Access Compliance Report

Public Rights-of-Way

(Curb Ramps)

Intersection ID: 14734	Main Street: DILWORTH_RD_WEST	Cross Street: ISLEWORTH_AV	Location:	S
ADA ID: B05CA9810E56	Ramp Type: Directional1	Initial Pass/Fail: Fail	Overall Compliance: No	Severity Score: 12.5
Codes/Mitigation Info/Possible Solution		Field Measurements/Component Compliance

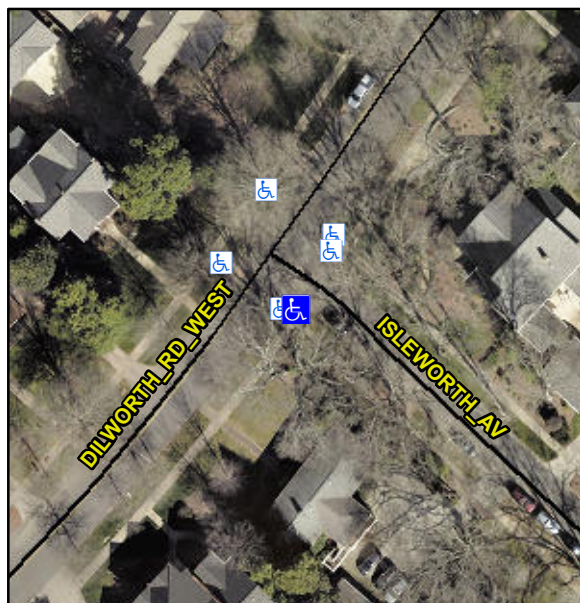
R304.2.2

Compliance	Description	Data	Compliance	Description	Data
N/A	Ramp Length (in)	48.0	N/A	Grade Break?	N/A
Yes	Ramp Width (in)	58.0	N/A	Grade Break Slope (%)	0.0
No	Ramp Slope (%)	9.7	N/A	Grade Break XSlope (%)	0.0
Yes	Ramp XSlope (%)	0.2			
N/A	Flare Type LT	N/A	N/A	Flare Type RT	N/A
N/A	Flare Slope LT (%)	N/A	N/A	Flare Slope RT (%)	0.0
N/A	Flare Traversable LT?	N/A	N/A	Flare Traversable RT?	N/A
N/A	Landing Length (in)	0.0	N/A	DWS Provided?	N/A
N/A	Landing Width (in)	0.0	N/A	DWS Contrast?	N/A
N/A	Landing Slope (%)	0.0	N/A	DWS Length (in)	N/A
N/A	Landing X Slope (%)	0.0	N/A	DWS Full Width?	N/A
N/A	Landing Curb? (Y/N)	N/A	N/A	DWS Offset LT (in)	N/A
N/A	Shared Landing?	N/A	N/A	DWS Offset RT (in)	N/A
N/A	Gutter Ponding?	0.0	N/A	Gutter Slope (%)	N/A
N/A	Gutter Lip Ht (in)	1.0	N/A	Gutter X Slope (%)	N/A
N/A	Painted X Walk1?	No		Road Slope (%)	0.6
	X Walk 1 Direction	To NE		Road X Slope (%)	0.5
	X Walk 1 Width (in)	N/A		Clear Space?	N/A

Remove & Replace Entire Ramp.
